SUBJECT: THREE MILE ISLAND NUCLEAR STATION, UNIT 1 - ISSUANCE OF
AMENDMENT RE: ADMINISTRATIVE TECHNICAL SPECIFICATION CHANGES
(TAC NO. ME7357)

AMENDMENT TO RENEWED FACILITY OPERATING LICENSE

Amendment No. 278
License No. DPR-50

Exelon	
Three Mile Island Nuclear Station	
EXTENDED PLOT PLAN	
CAD FILE: 6717R1.DWG	FIG 5-1

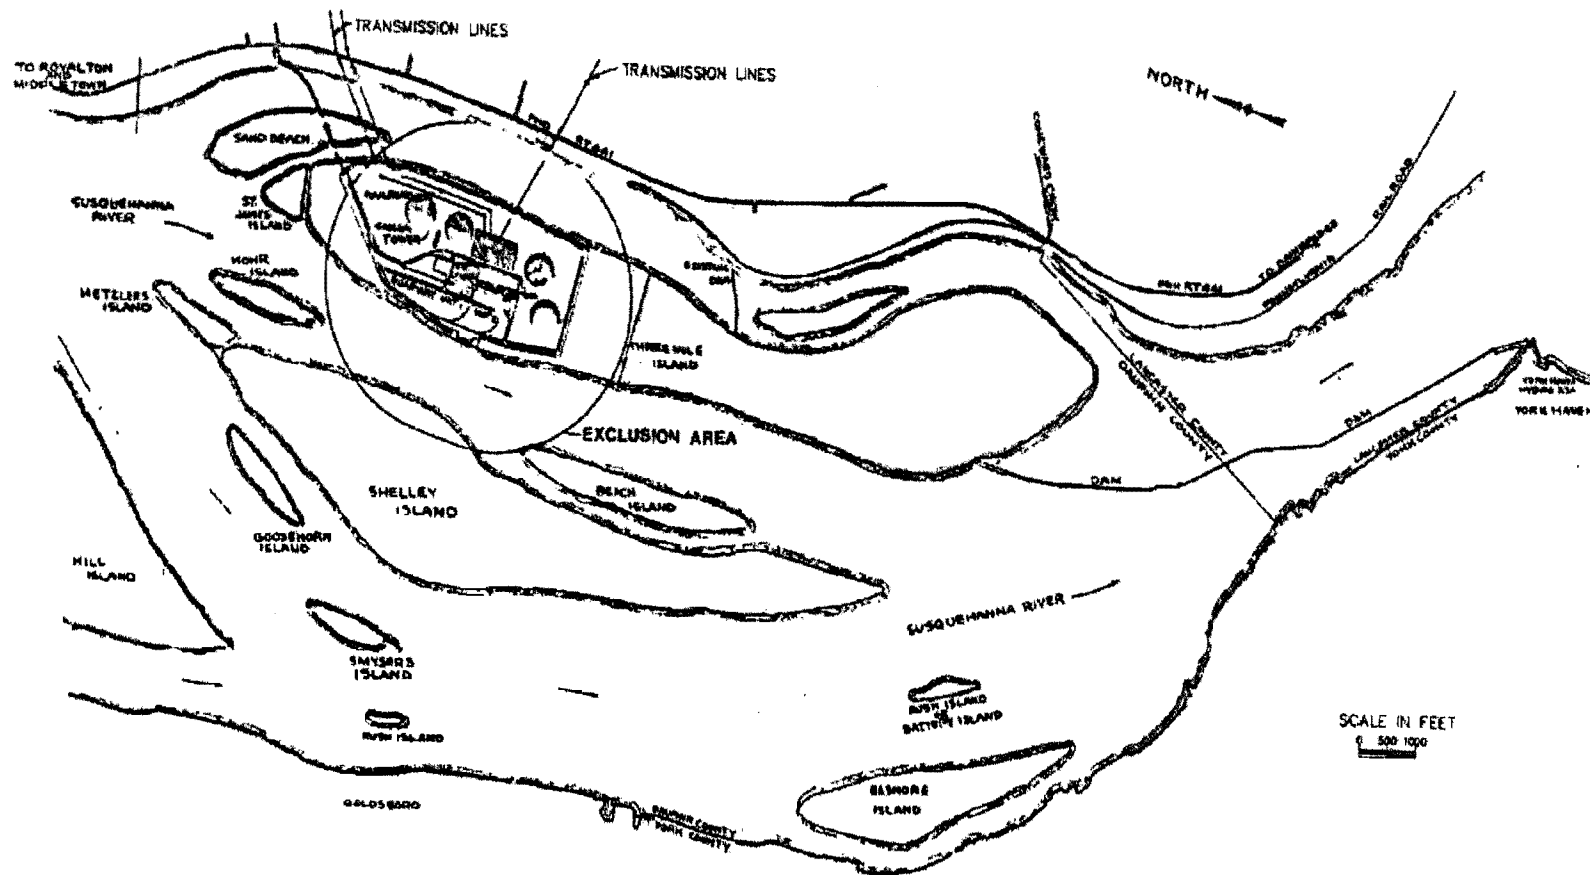
By letter dated January 20, 2012, the licensee also has proposed a change to TS 5.1.1 to refer to Figure "5-1" versus Figure "5.1" in the text of that TS. The NRC staff reviewed the

- (4) By letter dated January 20, 2012, the licensee proposed to revise the drawing title boxes for TS Figures 5-1 and 5-2 to reflect Exelon, the current TMI-1 licensee. TS Figure 5-3 is also proposed for a similar change, as requested in the licensee's letter dated October 18, 2011.

amendment history of TS 5.1.1 and discovered that the specification of Figure "5.1" was introduced with the clean copy pages of TMI-1 TS Amendment 218 (ADAMS Accession No. ML003670801). The previous amendment to this page, Amendment No. 149 (ADAMS Accession No. ML003765327), contains the correct reference to Figure "5-1" as reflected in the List of Figures (TS page vii), and the actual figure. The NRC staff, therefore, concludes that this change corrects a typographical error introduced inadvertently with Amendment No. 218. Based on this conclusion, as well as the NRC's determination that the requested change has no impact on plant safety, the NRC staff finds the proposed change acceptable.
